VALLEY VIEW LAKE DAM

NDI ID No. PA-01006
DER ID No. 19-75

PHASE I INSPECTION REPORT

DEPARTMENT OF THE ARMY
Baltimore District, Corps of Engineers
Baltimore, Maryland 21203

PHASE I INSPECTION REPORT
 NATIONAL DAM INSPECTION PROGRAM
 VALLEY VIEW LAKE DAM
 VALLEY VIEW LAKE ASSN.
 FIELD SKETCH
 EXHIBIT A-1

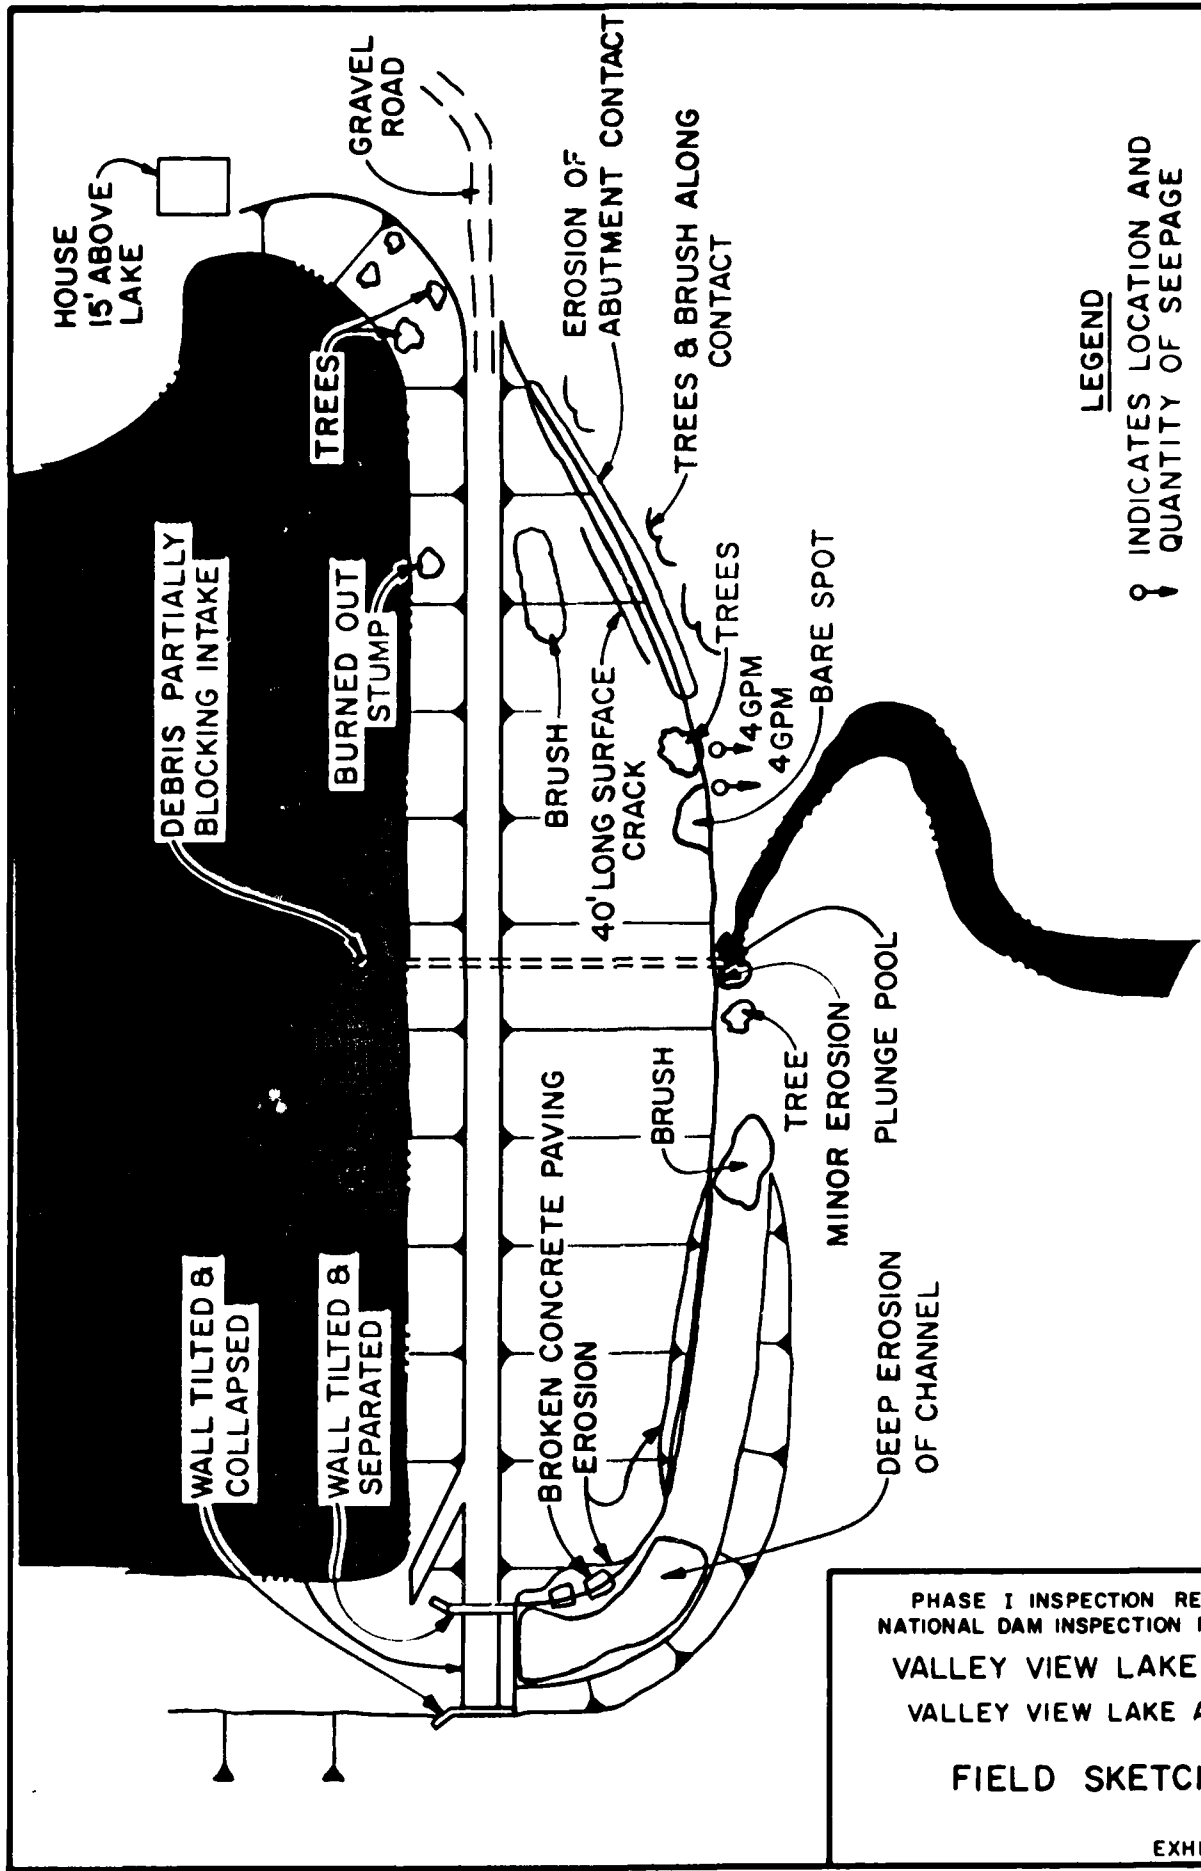
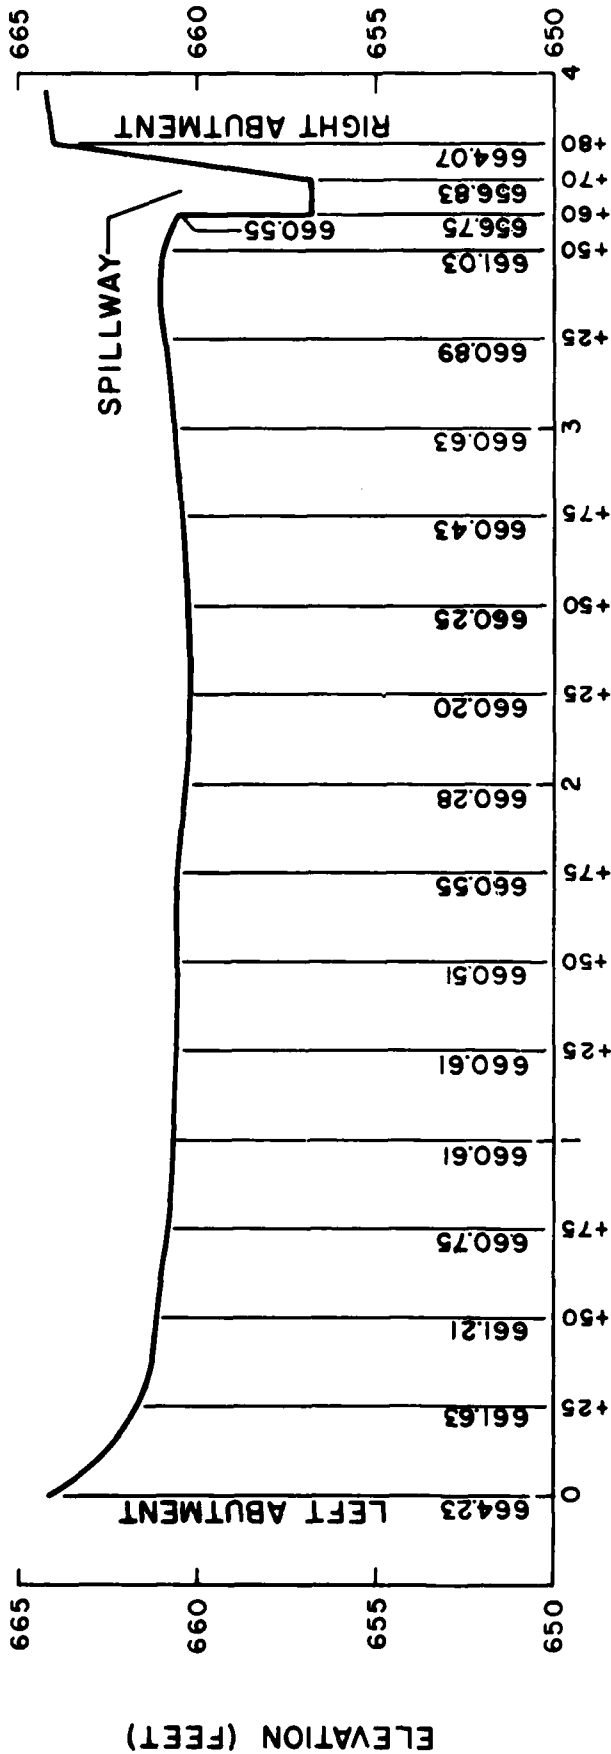
c. Appurtenant Structures. The location of the outlet works and the spillway are shown on the field sketch in Appendix A. The spillway approach channel is the reservoir with approximately the first 20 feet being grass covered. The spillway slab and walls are cracked and in poor condition. The left spillway wall is separated from the upstream wingwall and is tilting. Based on photographs in PennDER files, the right spillway wall was originally constructed to the same height as the left wall. Sometime after April 1964 the right wall was raised about 3 feet by placing concrete block with mortared joints on top of the existing wall. A 4 foot high by 6 foot long triangular section of this concrete block has failed. The remaining concrete block is leaning and separating at the mortared joints. The upstream end of the original concrete wingwall is also seriously cracked and leaning. Concrete in the form of a bulge is visible beneath the bridge and acts as a buttress for the right wall. The spillway walls and slab end approximately 4 feet downstream of the bridge. Material from the right abutment is covering a portion of the right side of the slab to a maximum depth of 2 feet.

5.3 Visual Observations. On the date of the inspection, conditions were present that may prevent the facility from operating as designed during a flood event. The spillway walls have deteriorated and are now leaning into the spillway opening. Immediately, downstream of the spillway slab, erosion has scoured out portions of the downstream channel adjacent to the embankment. This area had been filled with leaves and brush. Although this material presents no obstruction to flow, it did prevent a thorough inspection of the outlet channel. See Exhibit A-1 of Appendix A.
